PCN No.: 20210326.25

料号 PN	TYS4012100M-10/TYS4018101M-10/TYS40181R0N-10 TYS40183R3M-10/TYS4018470M-10/TYS5020100M-10 TYS50201R0N-10/TYS5020220M-10/TYS50204R7M-10 TYS5040100M-10/TYS5040101M-10/TYS50402R2N-10 TYS5040470M-10/TYS50406R8M-10/TYS8040100M-10 TYS8040470M-10/TYS80404R7N-10	日期 DATE	Mar-26-2021

客户变更通知单(Product/Process Change Notice)

变更前 Before:

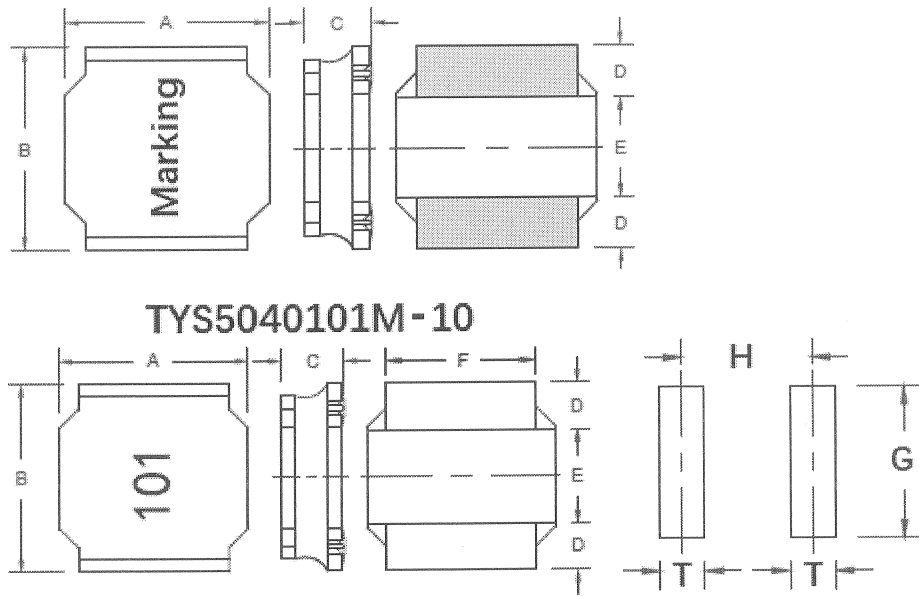
变更内容
What is the
Change About

Part No.	A	B	C	D	E	F	H	G	T
TYS4012100M-10	4.0±0.2	4.0±0.2	1.2+0.2/-0.3	1.3±0.3	1.4±0.3	N/A	2.7	4.0	1.5
TYS40181R0N-10	4.0±0.2	4.0±0.2	1.8+0.2/-0.3	1.3±0.3	1.4±0.3	N/A	2.7	4.0	1.5
TYS40183R3M-10	4.0±0.2	4.0±0.2	1.8 Max	0.95±0.2	2.1±0.2	N/A	3.0	3.4	1.1
TYS4018470M-10	4.0±0.2	4.0±0.2	1.8+0.2/-0.3	1.3±0.3	1.4±0.3	N/A	2.7	4.0	1.5
TYS4018101M-10	4.0±0.2	4.0±0.2	1.8+0.2/-0.3	1.3±0.3	1.4±0.3	N/A	2.7	4.0	1.5
TYS50201R0N-10	5.0±0.2	5.0±0.2	2.0+0.2/-0.3	1.25±0.3	2.5±0.3	N/A	3.8	5.0	1.4
TYS50204R7M-10	5.0±0.2	5.0±0.2	2.0+0.2/-0.3	1.25±0.3	2.5±0.3	N/A	3.8	5.0	1.4
TYS5020100M-10	5.0±0.2	5.0±0.2	2.0+0.2/-0.3	1.25±0.3	2.5±0.3	N/A	3.8	5.0	1.4
TYS5020220M-10	5.0±0.2	5.0±0.2	2.0+0.2/-0.3	1.25±0.3	2.5±0.3	N/A	3.8	5.0	1.4
TYS50402R2N-10	5.0±0.2	5.0±0.2	4.0+0.2/-0.3	1.6±0.3	1.8±0.3	N/A	3.4	5.0	1.8
TYS50406R8M-10	5.0±0.2	5.0±0.2	4.0+0.2/-0.3	1.6±0.3	1.8±0.3	N/A	3.4	5.0	1.8
TYS5040100M-10	5.0±0.2	5.0±0.2	4.0+0.2/-0.3	1.6±0.3	1.8±0.3	N/A	3.4	5.0	1.8

TYS5040470M-10	5.0±0.2	5.0±0.2	4.0+0.2/-0.3	1.6±0.3	1.8±0.3	N/A	3.4	5.0	1.8
TYS5040101M-10	5.0±0.2	5.0±0.2	4.0+0.2/-0.3	1.6±0.3	1.8±0.3	4.0±0.5	3.4	5.0	1.8
TYS80404R7N-10	8.0±0.3	8.0±0.3	4.0+0.2/-0.3	2.45±0.3	3.1±0.3	N/A	5.5	8.0	2.5
TYS8040100M-10	8.0±0.3	8.0±0.3	4.0+0.2/-0.3	2.45±0.3	3.1±0.3	N/A	5.5	8.0	2.5
TYS8040470M-10	8.0±0.3	8.0±0.3	4.0+0.2/-0.3	2.45±0.3	3.1±0.3	N/A	5.5	8.0	2.5
